Product change notification (PCN)

Title / short description	New equipment
Affected article category	Electronics housing
Change category	Form and appearance
Change number	PAC260010-00
Reason for PCN/PDN Revision

New plastic tool

PAC260010 / BC 107,6+71,6

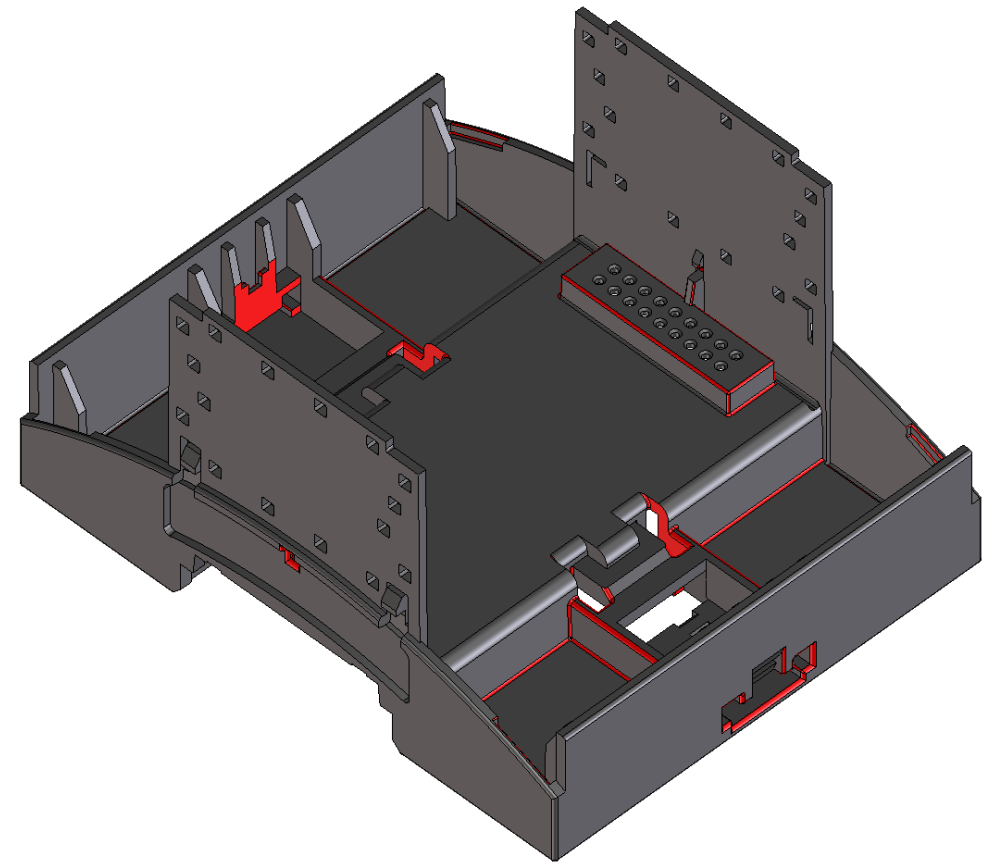
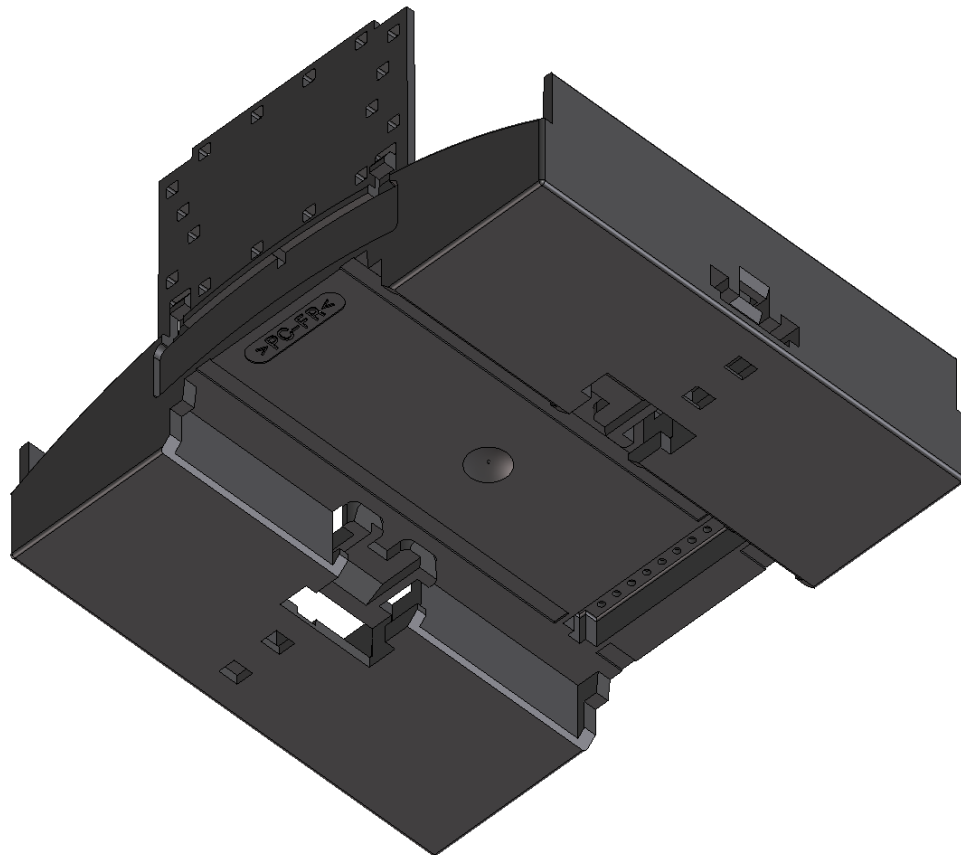
The previous plastic tool has reached the end of its service life and must be replaced with a new tool. As part of this, a product improvement will be introduced in the form of optimized radii and draft angles. The implemented modifications are minor and limited to small geometric optimizations. These changes do not affect the fit, form, or function of the component. All technical and functional properties remain unchanged, and full compatibility is maintained.
